PARTMENT	OF NA	OF UTAH TURAL RES GAS AND M					AMENDED REF	FORM 3	
		APPL	ICATION FOR F	PERMIT TO	D DRILL					1. WELL NAME and NUMBER MIKE AND SHELLEY #4-14A2

BOPE REVIEW DEVON ENERGY PROD CO LP MIKE AND SHELLEY #4-14A2 43013518460000

Application for Permit to Drill Statement of Basis

Permit To Drill

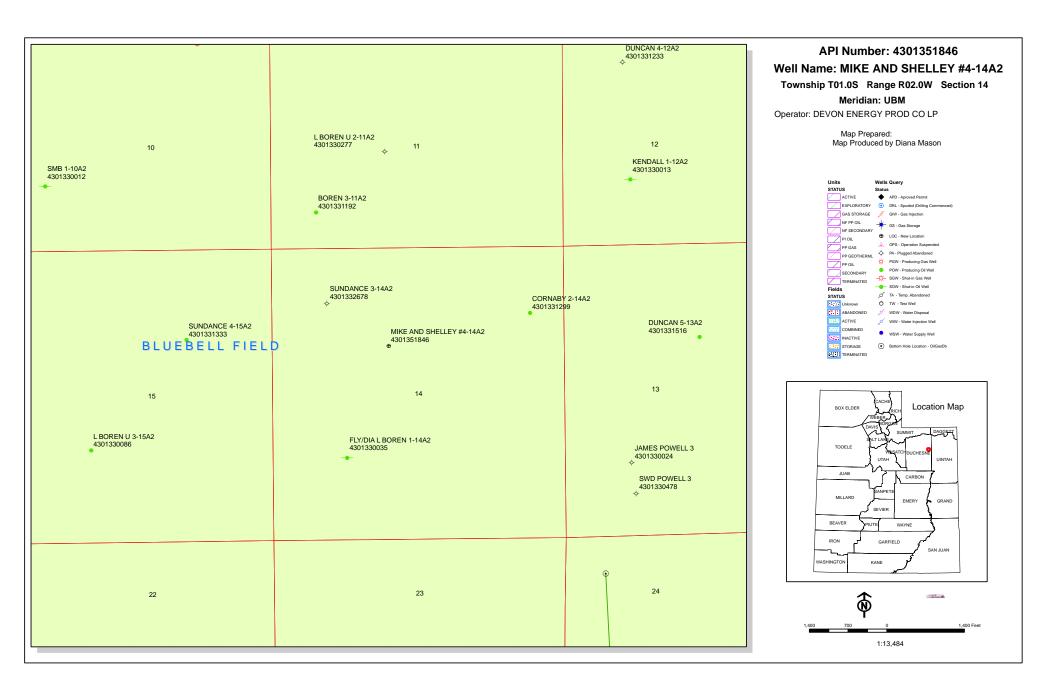
Well Name			KE AND SHELLE	Y #4-	-14A2 430135	i18		
String		SURF	I1	PROD	i II		i	
Casing Size(")		9.625	7.000	5.000	i l			
Setting Depth (TVD)		2500	10750	13900	i []	
Previous Shoe Setting Dept	h (TVD)	0	2500	10750	i []	
Max Mud Weight (ppg)		10.0	10.5	14.5	i []	
BOPE Proposed (psi)		1000	5000	10000	i []	
Casing Internal Yield (psi)		5750	11220	13940	i []	
Operators Max Anticipated	Pressure (psi)	10481		14.5	Ī.		Ī	
Calculations SURF String					9.625	"		
Max BHP (psi)			52*Setting D	epth*MW=	T12	300		
(F**)				-P	113	500	BOPE Ade	quate For Drilling And Setting Casing at Depth?
MASP (Gas) (psi)	Max BHP-(0.12*Setting Depth)=		10	000	NO I	diverter with rotating head		
MASP (Gas/Mud) (psi)	Max BHP-(0.22*Setting Depth)=		75	50	YES	ОК

-		1	Expected Pressure Be Held At Previous Shoe?
Pressure At Previous Shoe Max BHP22*(Setting Depth - Previous Shoe Depth)=				75	50	NO	ОК	
Required Casing/BOPE Test Pressure=			25	500	psi			
*Max Pressure Allowed @ Previous Casing Shoe=				0		psi *Ass	sumes lpsi/ft frac gradient	
						= 000		
Calculations Max BHP (psi)		I1 Strin		anth*MW-	H	7.000	<u> </u>	
wiax Birr (psi)	.052*Setting Depth*MW=			58	370	ROPE Ade	quate For Drilling And Setting Casing at Depth?	
MASP (Gas) (psi)	Max BHP-(0.12*Setting Depth)=			1/45	80	YES YES	quate For Drining And Setting Casing at Depth.	
MASP (Gas/Mud) (psi)					H	505	YES	ОК
······································	Max BHP-(0.22*Setting Depth)=				30	505	1	Expected Pressure Be Held At Previous Shoe?
Pressure At Previous Shoe	Max BHP22*(S	etting Depth	- Previous Sh	oe Depth)=	40	055	NO I	ОК
Required Casing/BOPE Tes	st Pressure=				78	354	psi	
*Max Pressure Allowed @	Previous Casing	Shoe=			25	500	psi *Ass	sumes 1psi/ft frac gradient

PROP G				7 000		
Calculations Max BHP (psi)		PROD Str	ing 52*Setting D	lenth*MW-	H	5.000		
Hax DIII (psi)			52 Setting D	reptii WW =	10	0481	BOPE Ade	quate For Drilling And Setting Casing at Depth?
MASP (Gas) (psi)		Max BH	P-(0.12*Setti	ng Depth)=	88	313	YES	quite 1 of 2 1 ming 1 min decising cusing at 2 epoin
MASP (Gas/Mud) (psi)		Max BH	P-(0.22*Setti	ng Depth)=	74		YES	ОК

-		1	Expected Pressure Be Held At Previous Shoe?
Pressure At Previous Shoe	Max BHP22*(S	etting Depth	- Previous Sh	oe Depth)=	97	788	YES	
Required Casing/BOPE Tes	st Pressure=				97	758	psi	
*Max Pressure Allowed @	Previous Casing	Shoe=			10	750	psi *Ass	sumes 1psi/ft frac gradient
Calculations		String					"	
Max BHP (psi)			52*Setting D	epth*MW=	┢			
4 /				1	-		BOPE Ade	quate For Drilling And Setting Casing at Depth?
MASP (Gas) (psi)		Max BH	P-(0.12*Setti	ng Depth)=	E		NO	
MASP (Gas/Mud) (psi)		Max BH	P-(0.22*Setti	ng Depth)=	۱Ē		NO	
							*Can Full	Expected Pressure Be Held At Previous Shoe?
Pressure At Previous Shoe	Max BHP22*(S	etting Depth	Previous Sh	oe Depth)=			NO	
Required Casing/BOPE Tes	st Pressure=						psi	
*Max Pressure Allowed @ Previous Casing Shoe=				IF		psi *Ass	sumes 1psi/ft frac gradient

43013518460000 Mike and Shelley 4-14A2

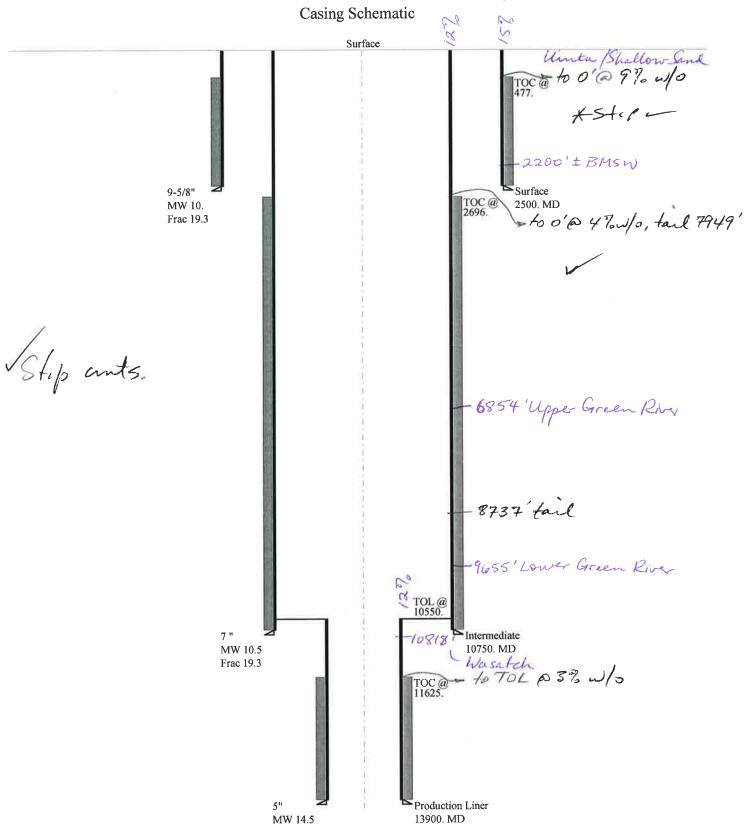
Collapse is based on a vertical depth of 2500 ft, a mud weight of 10 ppg. The casing is considered to be evacuated for collapse purposes. Collapse strength is based on the Westcott, Dunlop & Kemler method of biaxial correction for tension.

Burst strength is not adjusted for tension.
